Informal document **GRSG-115-10-Rev.1**
(115th GRSG, 9-12 October 2018
Agenda item 6(b))

Revised proposal for a new UN Regulation on uniform provisions concerning the approval of motor vehicles with regard to the Blind Spot Information System for the Detection of Bicycles

(Amendments to ECE/TRANS/WP.29/GRSG/2018/24 as adopted by GRSG at its 115th session)

Figure 1
Dynamic tests

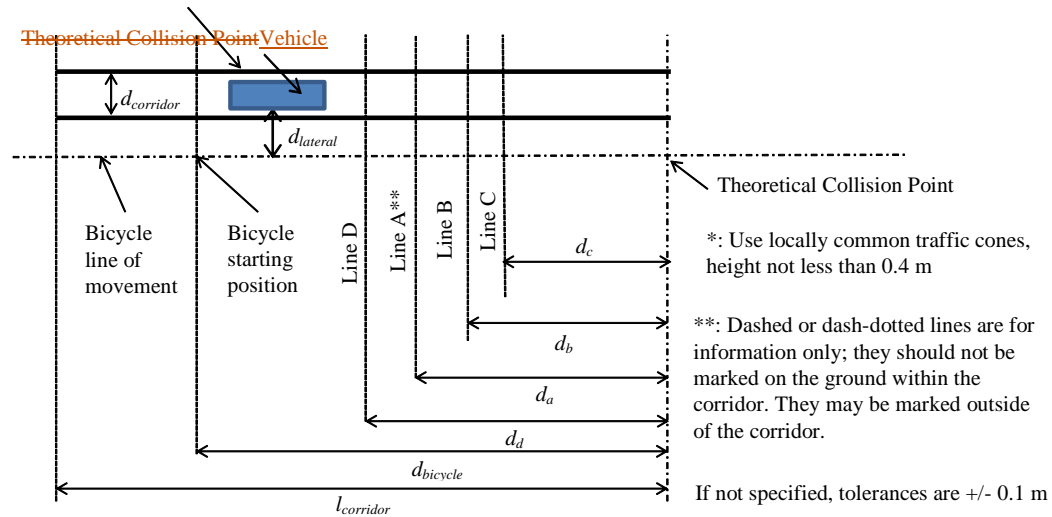
- 6.5.7. Verify if the Blind Spot Information signal has been activated before the vehicle crosses line C in Figure 1 of Appendix 1 to this Regulation, and if the Blind Spot Information signal has not been activated before the vehicle crosses line D in Figure 1.

For vehicle speeds up to 5 km/h, it is deemed satisfactory if the information signal is activated 1.4 seconds before the bicycle has reached the theoretical collision point as specified in Appendix 1, Figure 1. For vehicle speeds between 5 and 10 km/h, the value d_c shall be 5 m.

For vehicle speeds above 25 km/h, where the stopping distance is higher than 15 m, d_c as specified in Appendix 1, Figure 1 shall be as specified in Appendix 1, Table 2.

Figure 2
Static tests

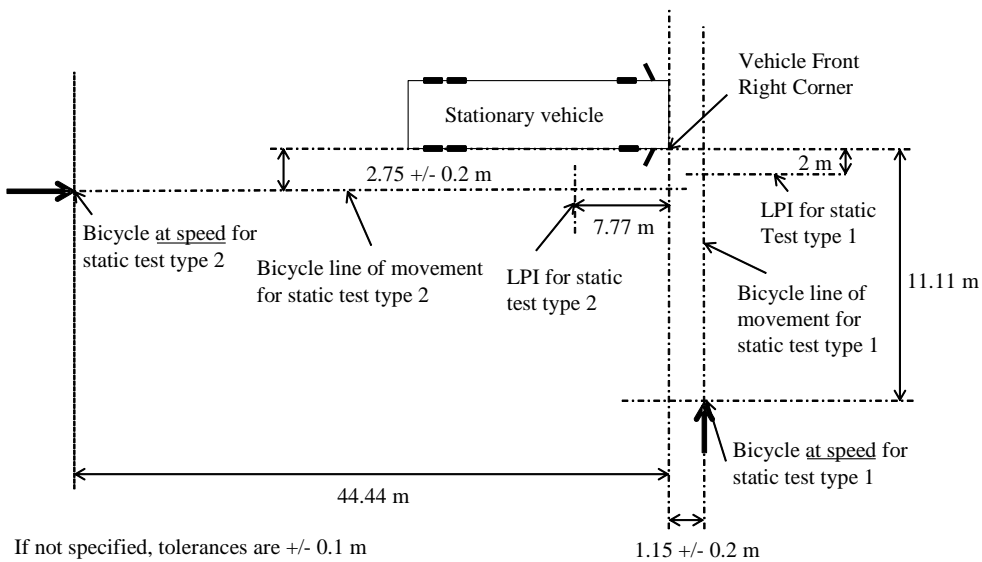
Leave the vehicle under test stationary. Then manoeuvre the bicycle dummy perpendicular to the longitudinal median plane of the vehicle with an impact position 1.15 m in front of the most forward point of the vehicle, with a speed of 5 ± 0.5 km/h and a lateral tolerance of 0.2 m, as shown in Figure 2 in Appendix 1.

Leave the vehicle under test stationary. Then manoeuvre the bicycle dummy parallel to the longitudinal median plane of the vehicle, with a lateral separation of 2.75 ± 0.2 m, with a bicycle speed of 20 ± 0.5 km/h, as shown in Figure 2 of Appendix 1. The bicycle should be at constant speed at least 44 m before passing the most forward vehicle point.

The test is passed if the Blind Spot information signal is activated at the latest when the bicycle is 7.77 m away from the projection of the vehicle's most forward point to the bicycle line of movement.
